**RECORD OF DECISION FOR THE
LANDFILL OPERABLE UNIT OF THE
TONAWANDA LANDFILL VICINITY PROPERTY
TONAWANDA, NEW YORK**

**AUTHORIZED PROJECT UNDER THE
FORMERLY UTILIZED SITES REMEDIAL ACTION PROGRAM**

September 2017

FIGURE 6-1

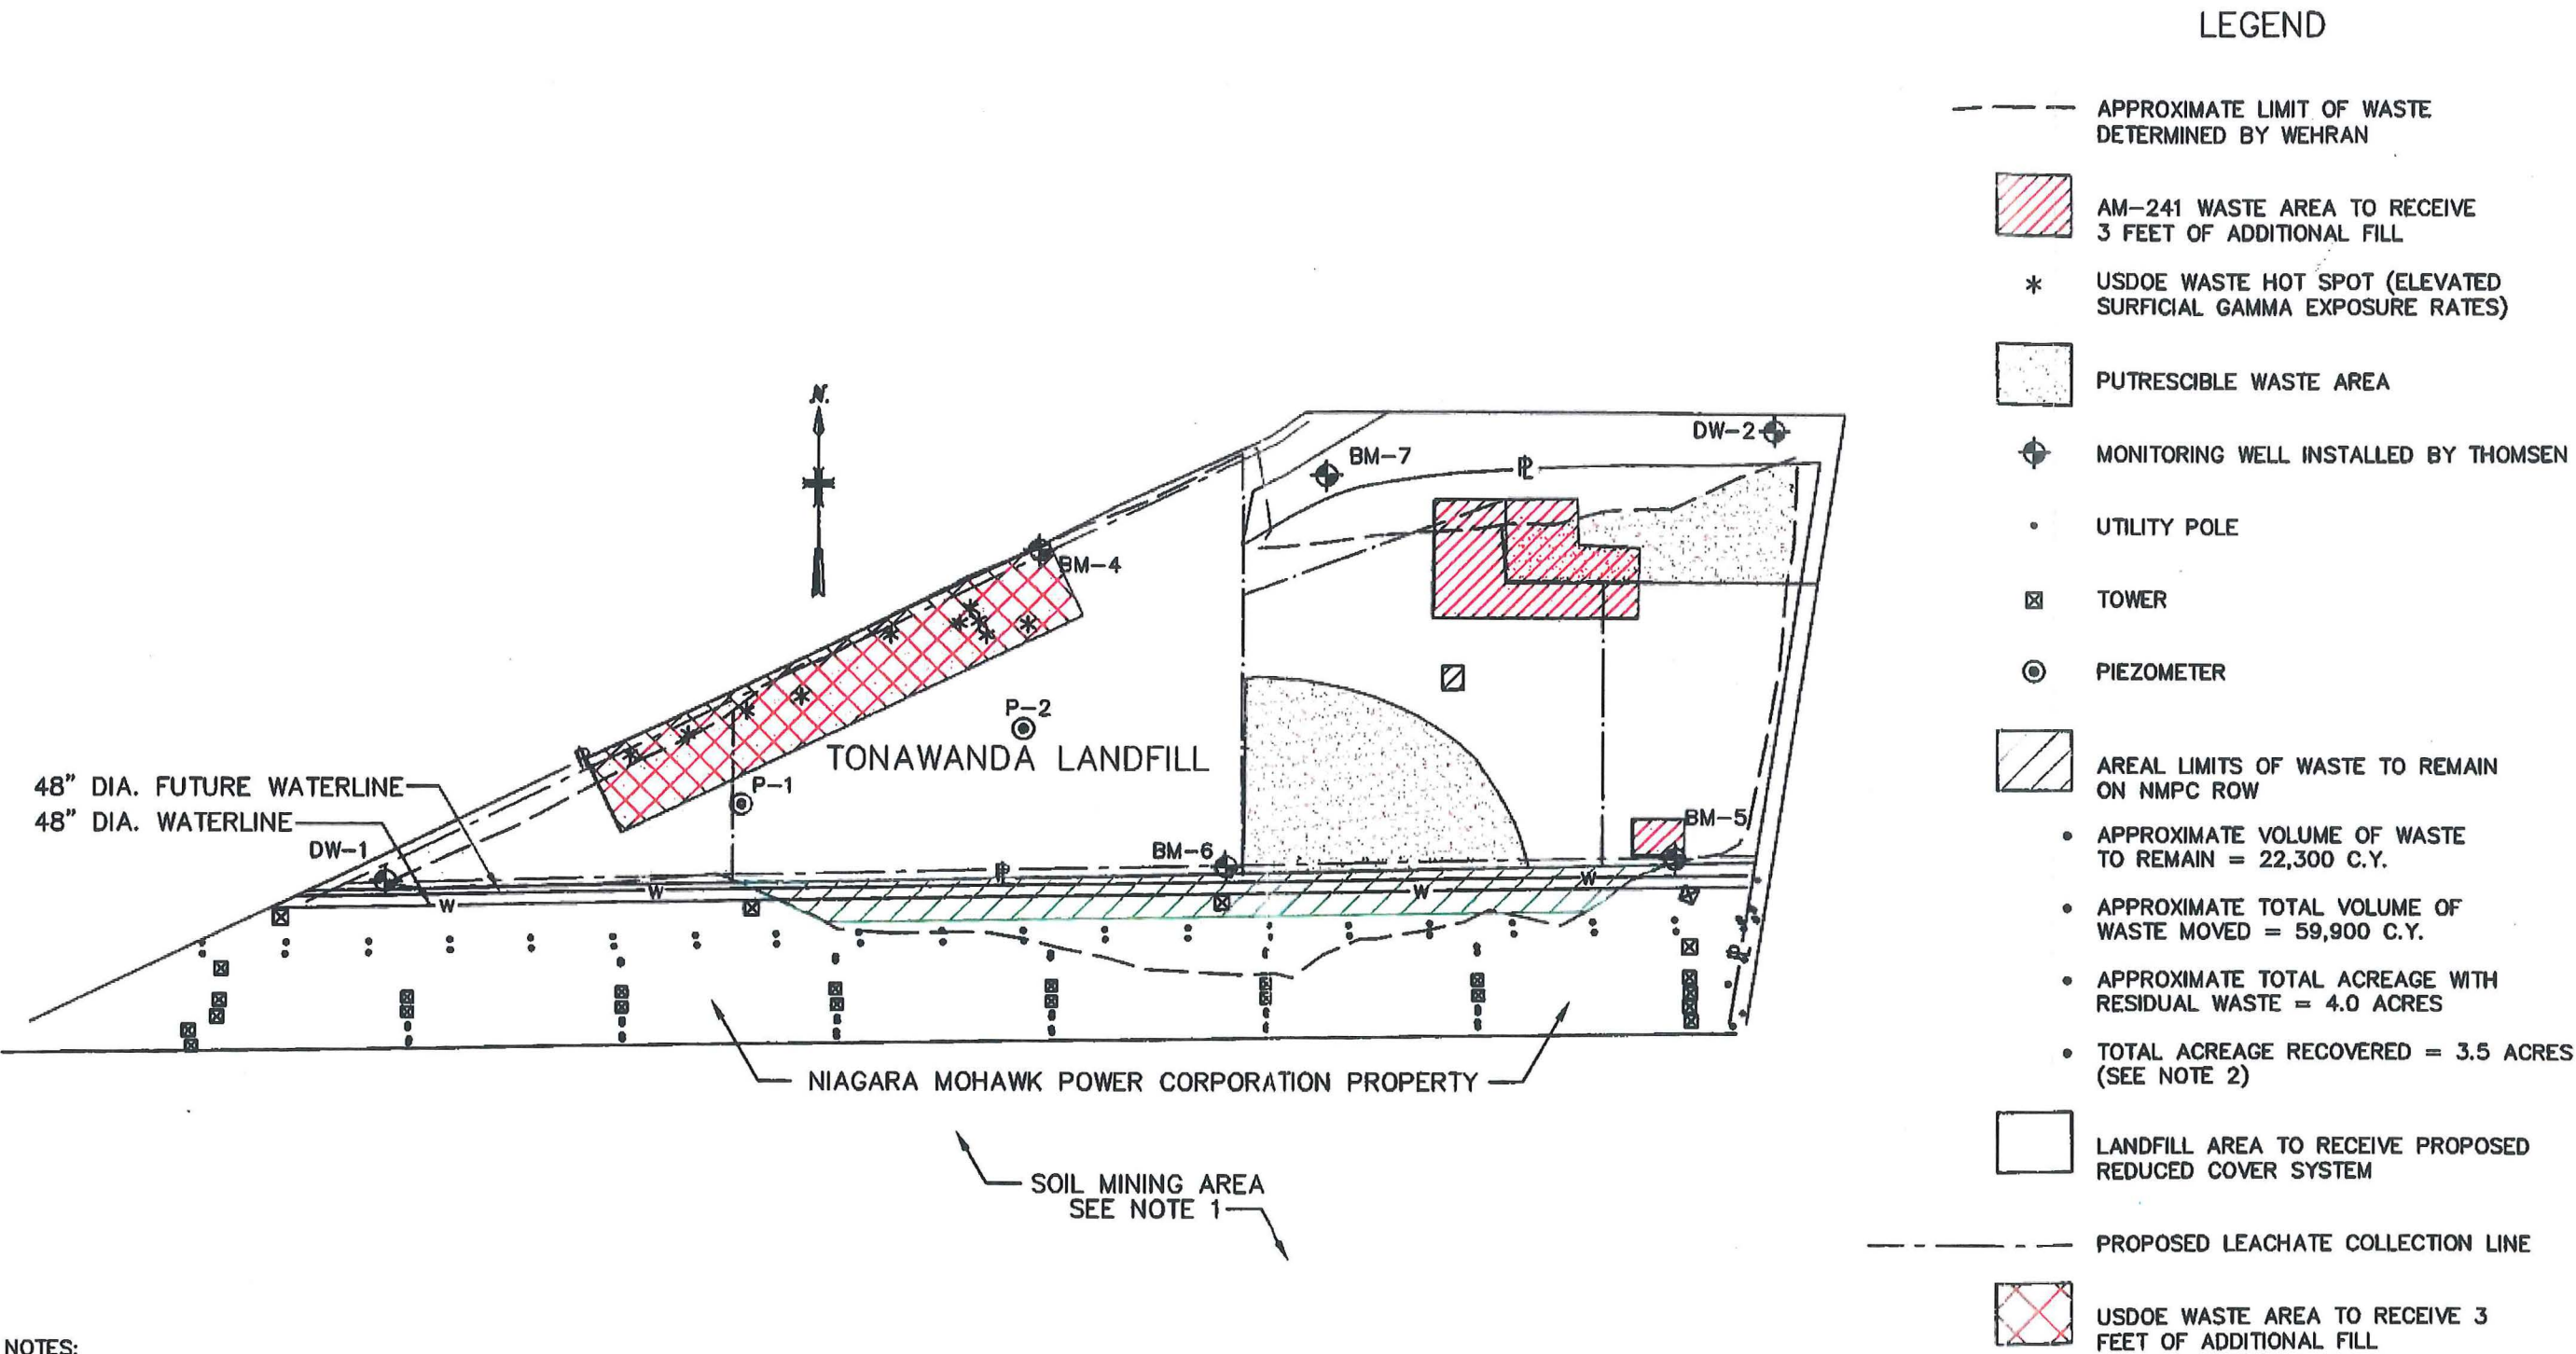
- In areas that received Americium-241 contaminated ash, provide an additional three feet of clean fill material. The approximate limits of the Americium-241 areas are shown on Figure 6-1.

- In areas where uranium by-products were disposed, provide a minimum of three feet of cover material. The approximate location of the areas which received uranium by-products are shown on Figure 6-1.
